# CITY OF DELRAY BEACH

HISTORIC PRESERVATION BOARD STAFF REPORT				
Swinton Social – 27 S. Swinton Avenue				
Meeting	File No.	Application Type		
May 7, 2025	2025-134	In-Lieu of Parking Fee Request		
REQUEST

The item before the Board is a recommendation to the City Commission for an In-Lieu of Parking (2025-134) request to allow 20 In-Lieu of Parking Spaces for the proposed commercial project located at 27 S. Swinton Avenue known as **Swinton Social**, **Old School Square Historic District**.

Approved Site plan for 27 S. Swinton Ave showing the 3 new on-street parking spaces (in red).

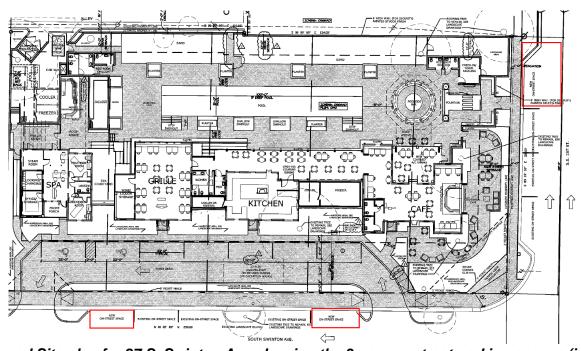
The subject request includes the use of the three (3) newly constructed on-street parking spaces to be credited to their required parking requirements. Below is a screenshot of the certified site plan depicting the new parallel parking spaces, two which are located on the west side of the property on S. Swinton Ave, with the third located on the southeast corner of the property on S.E 1<sup>st</sup> Street. These spaces are abutting the existing property and are publicly accessible. If these spaces were to be removed in the future, the property's required parking would be considered legally nonconforming.

1. That the site data table on the site plan be revised to note 20 parking spaces as "Approved In-Lieu of Parking Fee Spaces".
